PD Modification Application: PRS 23-0154

Hillsborough County Florida

Development Services Department

1.0 APPLICATION SUMMARY

2.4 Proposed Site Plan (partial provided below for size and orientation purposes. See Section 8.2 for full site plan)

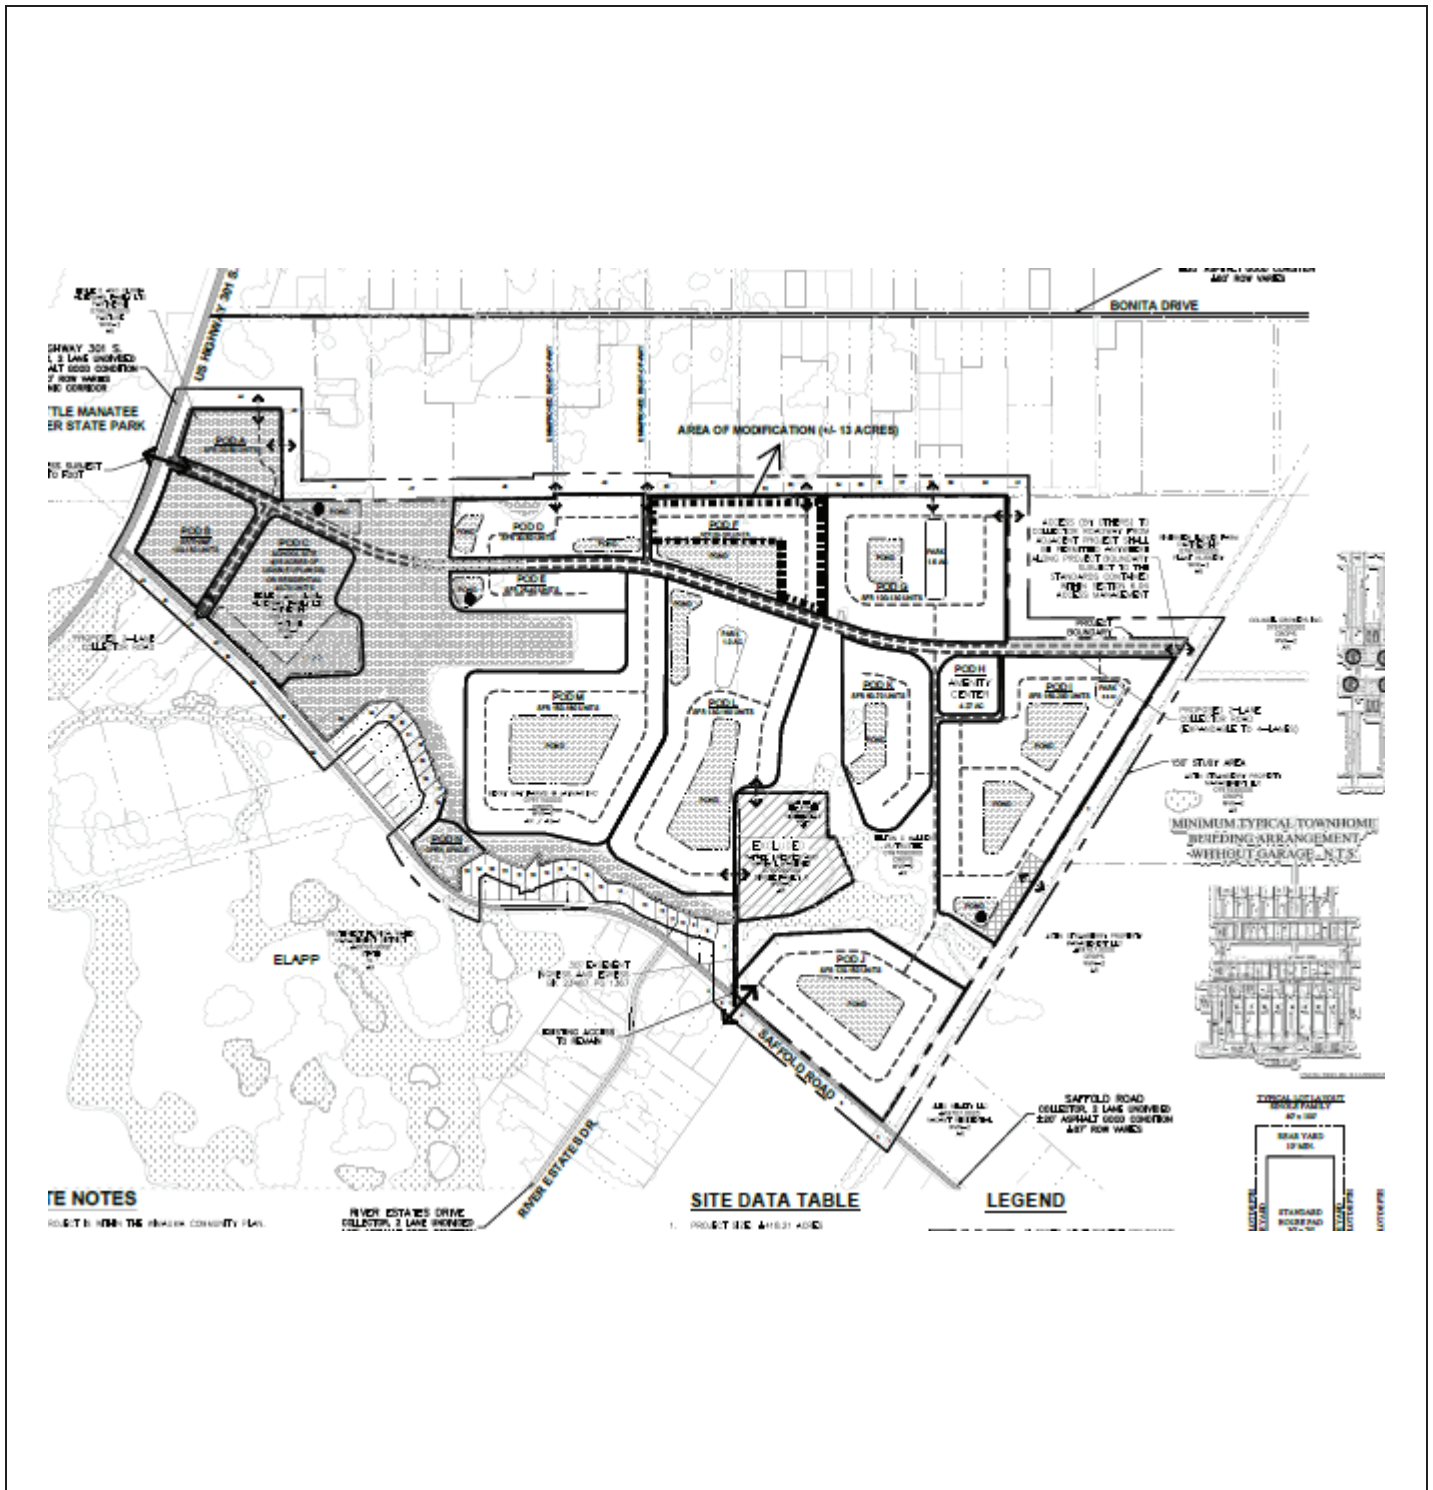
Pod F proposed for 60-100 single family lots. The proposed range is based upon site engineering conducted since the approval, which now proposes an accurate range.

The modification request is limited to Pod F, which is approved for single-family lot in the range of 60-80 lots. The range is proposed to be expanded by 20 units from 80 to 100 lots at the maximum. No change to the minimum lot size or pod size is proposed. Pod F is located along the northern boundary of the PD. Abutting properties consist of large lots developed with agricultural uses. The closest residential structures are 450 – 700 feet from the common boundary.

Approvable, subject to proposed conditions of approval.

8.2 Proposed Site Plan (Full)

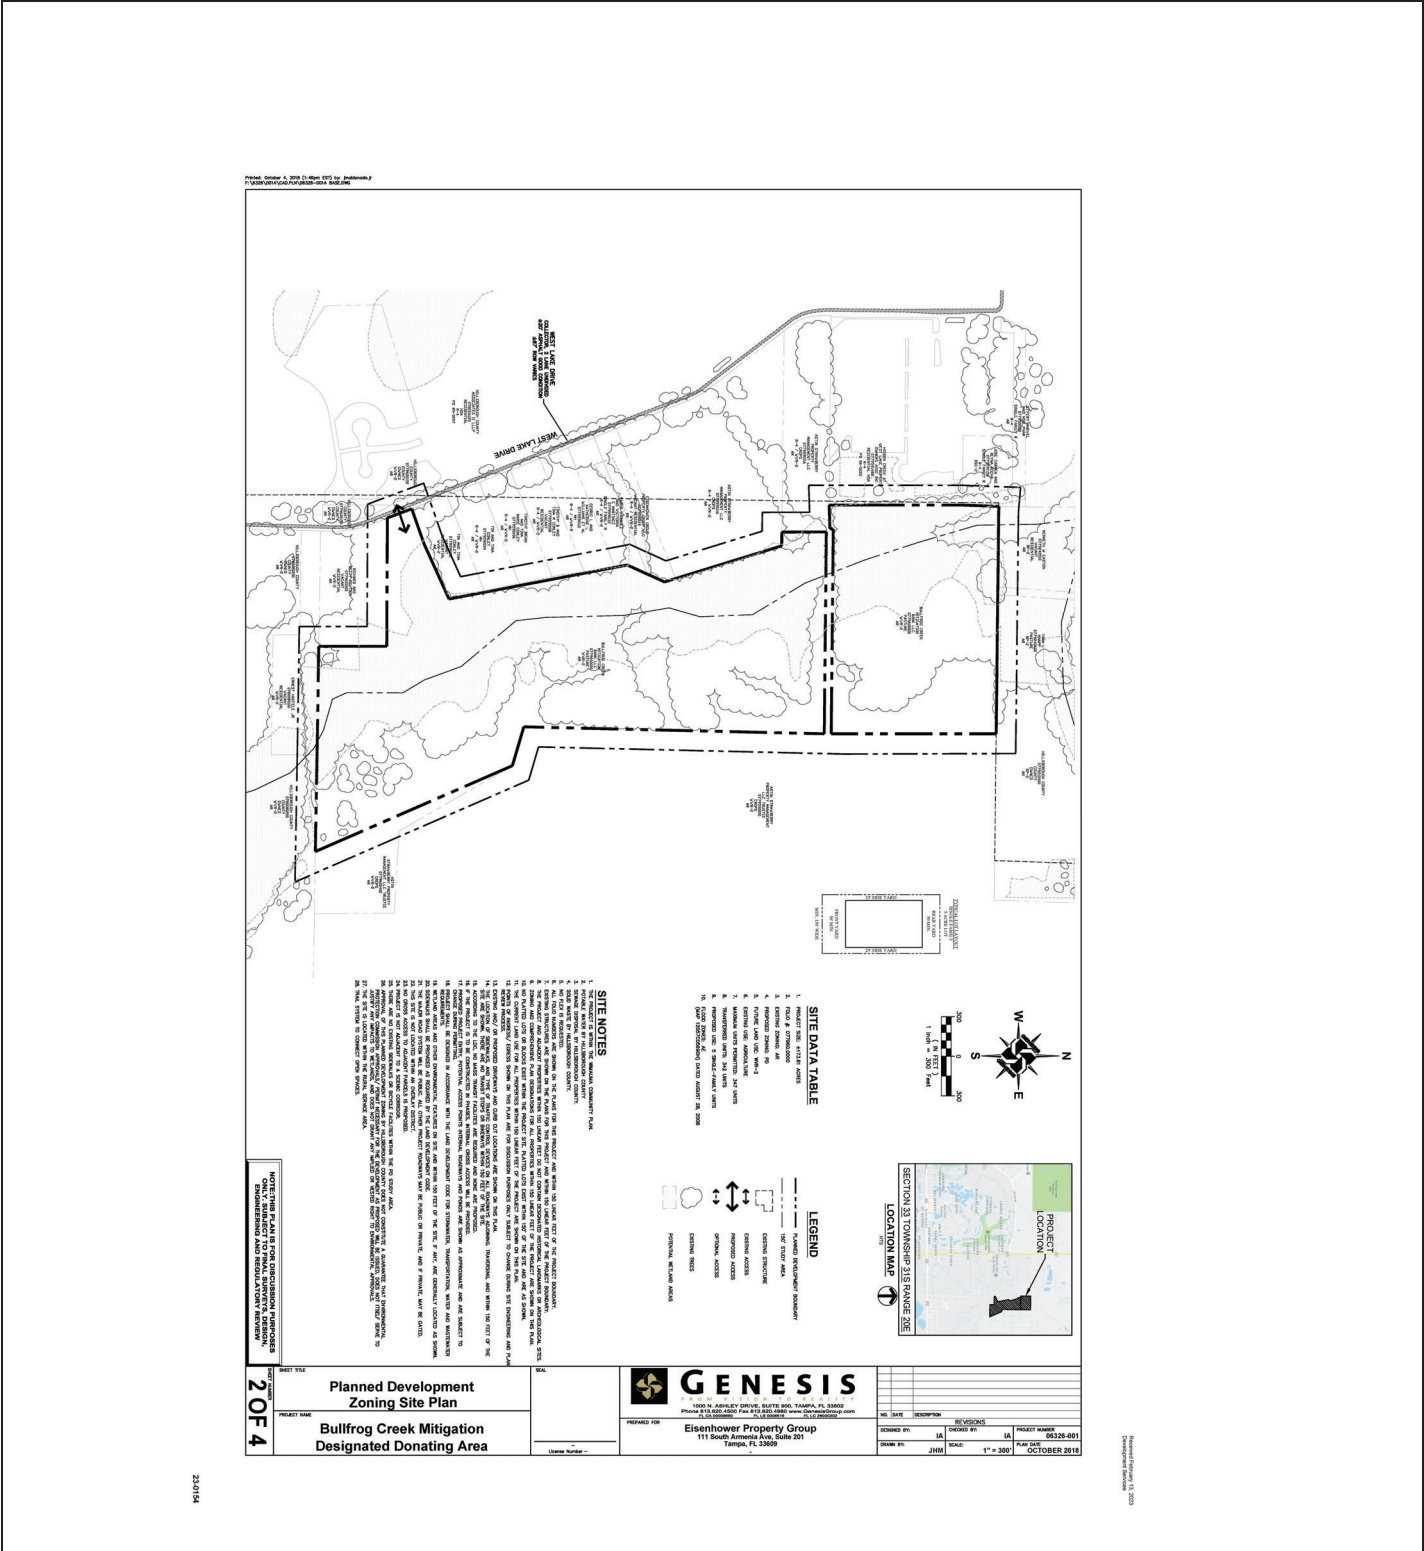
- County staff previously objected to the rezoning due to a lack of required analysis indicating the proposed minor modification would not have any impact on required turn lanes per LDC section 6.04.04.D. The applicant has since submitted the required analysis. The submitted analysis confirms that the proposed change would not require any modification to existing turn lanes or require additional turn lanes per LDC requirements. Transportation staff has no objection to the minor modification.

The applicant is requesting a minor modification (PRS) to PD 19-0102 (most recently modified by MM 22-1301). The proposed minor modification proposes to adjust the housing unit range in POD F from 60-80 units to 60-100 units. The proposed change does not impact the previously approved overall entitlements.
